March 28, 2022

On behalf of the Fenestration and Glazing Industry Alliance (FGIA), we are providing feedback on the proposed ENERGY STAR 7.0 Draft 2 Residential Windows, Doors, and Skylights Specification requirements. FGIA represents more than 350 member companies who manufacture and market windows, doors and skylights and the components that go into them for residential and commercial applications — many of whom are ENERGY STAR partners who label millions of products every year with the ENERGY STAR label.

The Difference Between Source and Site Energy

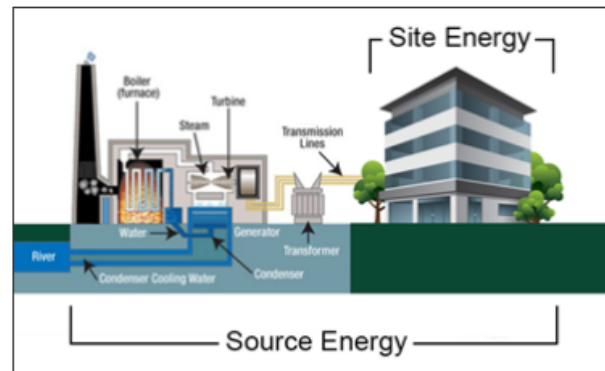
By its own admission in the [ENERGY STAR Portfolio Manager](#), "EPA Recommends Using Source Energy." EPA further states, "EPA has determined that *source energy* is the most equitable unit of evaluation for comparing buildings to each other" as shown below.

ENERGY STAR program specifications for windows for versions 1-6 all used SOURCE energy. So why was the change made in the Version 7.0 Draft 2 specification to SITE energy? This represents a major, significant, change in program direction and precedence. On what technical basis was the change to SITE instead of SOURCE energy made in this version?

FGIA challenges EPA to resolve the conflict and base the program for windows, doors, and skylights on SOURCE energy.
